# Technical Bulletin (TB-0059)

## GSD Compressor DV2 Upgrades

Version 1, January 2017

### Discharge Temperature Sensor (GSD8 Only)

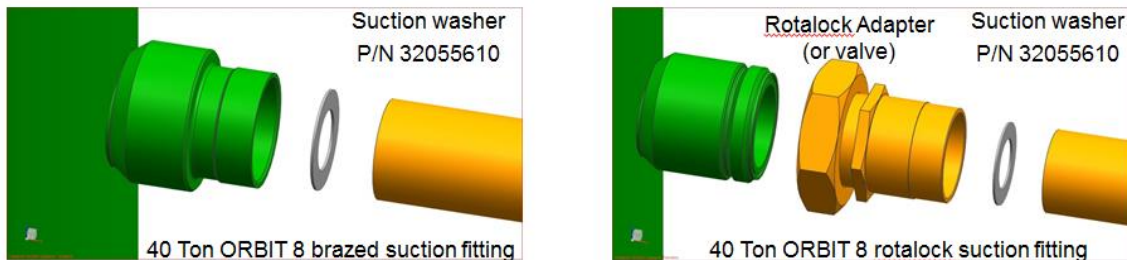
The DV2 version of the GSD8 compressor no longer has a port on the discharge connection for an insertion type temperature sensor. As a result, a new sensor kit (p/n 347054-01) has been developed to accommodate this design change. This sensor is a strap-on type, see figures below.

## Suction Washer (GSD8 Only)

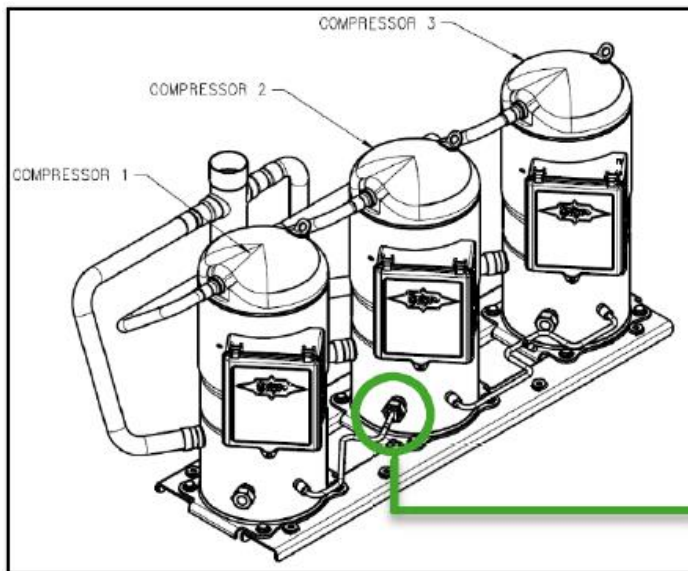
A suction washer (p/n 320556-10) is needed when field replacing an existing GSD80485 DV1 compressor with a GSD80485 DV2 compressor ONLY in a tandem or trio application. See the figure below for washer placement. The suction washer is installed in the DV2 compressor only.
